MIL "ON" DTC P0401

Service Category Engine/Hybrid System

Some 2011 – 2012 model year CT 200h vehicles equipped with a 2ZR-FXE engine may exhibit a MIL "ON" condition with Diagnostic Trouble Code (DTC) P0401 (*Exhaust Gas Recirculation Flow Insufficient Detected*) present. The Exhaust Gas Recirculation (EGR) Valve has been improved to address this condition.

Figure 1.

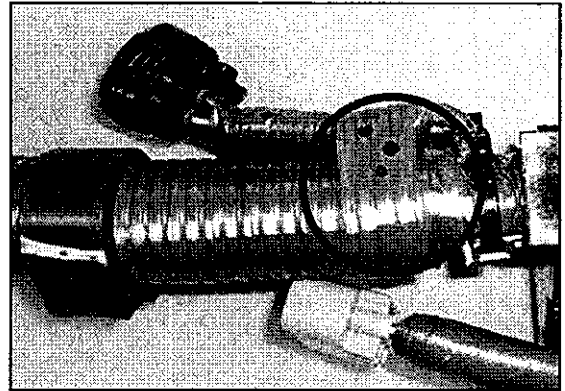
A. Remove the vinyl tape wrapped around the main harness and the EGR harness.

Figure 2.

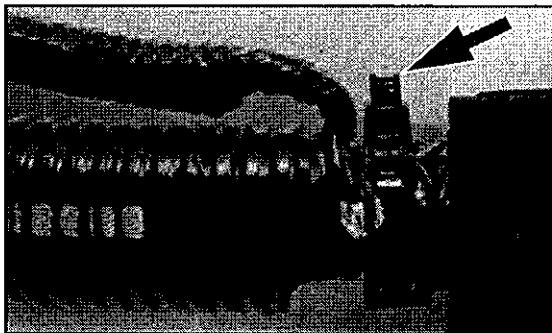
B. Wrap the exposed zip tie 7 – 8 times with the heat-resistant vinyl tape.
